CAN-AM*

Service Bulletin

Subject CHOKE ASSEMBLY
 Models 3841 and 3851 (TNT 125 and 175cc)
 Serial nos. From All to incl.
 Date July 19, 1973

Subject PISTON BREAKAGE

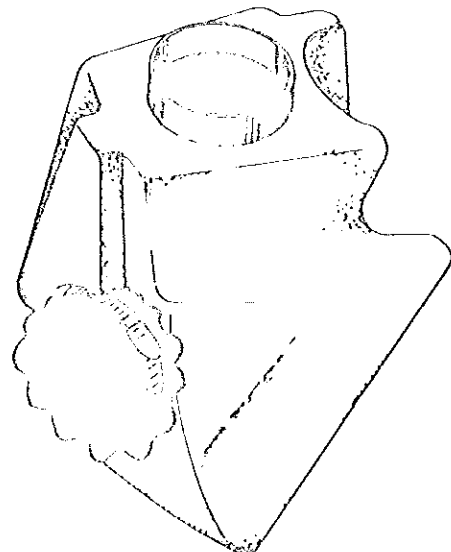
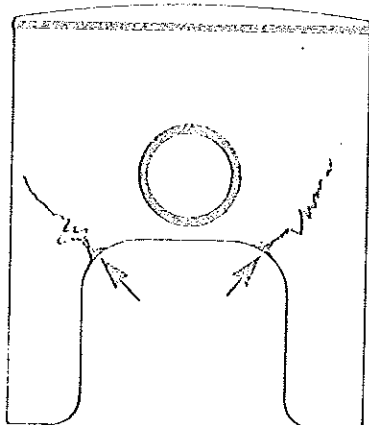
Piston breakage generally occurs when piston/cylinder clearance is excessive due to piston wear. Rapid piston wear is the direct result of dust entering the engine through the intake system.

Every time the filter is serviced, the air box should be checked for leaks. To do so, remove the air box/carburetor rubber adaptor, block the carburetor/air box opening with a piece of old tube and a collar. Fill the box with water. Any leak should be repaired with fiberglass resin or with silicone rubber. When this operation is completed, make

If dust is suspected to have entered the engine, check for excessive clearance between piston and cylinder.

125cc :	Min. 0.0025"	Max. 0.006"
175cc :	Min. 0.0025"	Max. 0.006"
